## Committee of the Whole Report For the Meeting of April 12, 2018

**To:** Committee of the Whole **Date:** April 6, 2018  
**From:** Fraser Work, Director of Engineering and Public Works  
**Subject:** Wastewater Treatment Project – Staff Review

The purpose of this report is to provide Council with the design information pertaining to the CRD Clover Point Pump Station and Dallas Road conveyance Forcemain, in order to progress to 90% design and project tender.

Figure 2 – Mile 0 Redesign Areas of Concern

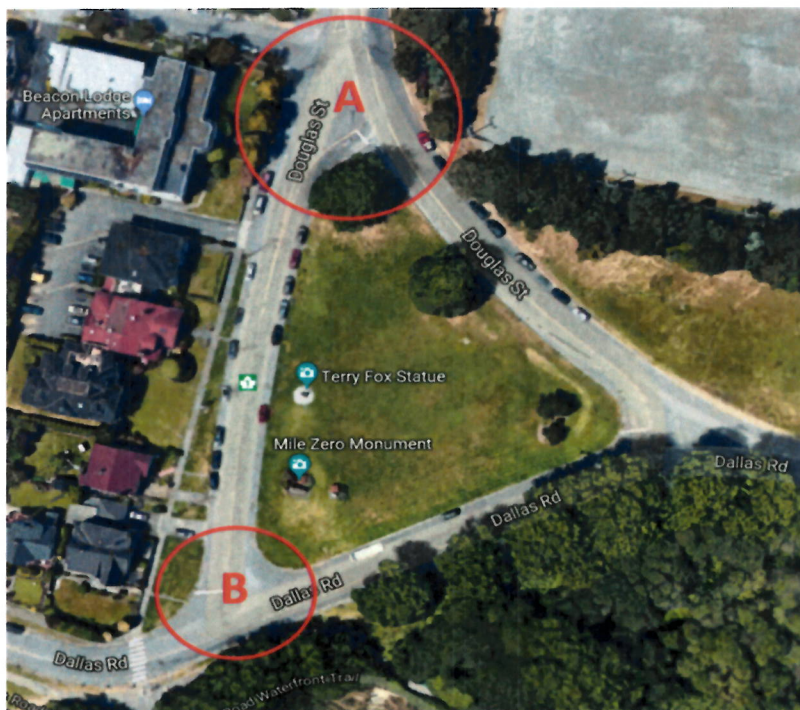
The project development surrounding the Mile 0 location generated feedback from community, as there is an interest within community to realign Douglas Street/ Dallas Road and Beacon Hill Park boundaries, to consolidate green space into the main portion of Beacon Hill Park.

The main consideration from staff is whether this is the appropriate time to consider redesigning this particular site. Staff assess that any redesign of this roadway would not be within scope of the CRD project due to proximity issues and would require significant planning, engagement and park/roadway design which are not achievable within current project timelines.

Re-design would require realignment of the entire section of Douglas Street between Niagara Street and Dallas Road, to provide safe motor vehicle approaches/sight lines - utilizing the existing westerly leg of Douglas Street at Dallas Road is not recommended, as sightlines for southbound left turn vehicles would be insufficient (see Figure 2 below, showing areas of concern). Staff also note that no capital work (EPW utilities upgrades, road reconstruction, or Parks Master Plan-related improvements) at this intersection is currently identified in the Financial Plan.

A number of optional cycle track alignments on Dallas Road at Mile 0, including an on-street option, were also reviewed by CRD and staff. The proposed alignment was determined to be the optimal alignment, as it retains mature trees along the boulevard, triggers removal of some of the invasive species between Dallas Road and the bluffs, while creating an enjoyable route through the park separate from vehicle traffic. The on-street alignments were assessed but not progressed as narrowing, or altering the north curb on the Mile 0 frontage resulted in insufficient tracking space for buses/larger vehicles currently using Dallas Road. Any redesign of this zone would be beyond the scope of the CRD project.

Any future optimisation of Mile 0 green-space and the adjacent roadway would require extensive planning and would ideally be undertaken following further public consultation, across City departments and the public. This work is not currently part of the upcoming, defined financial planning process.
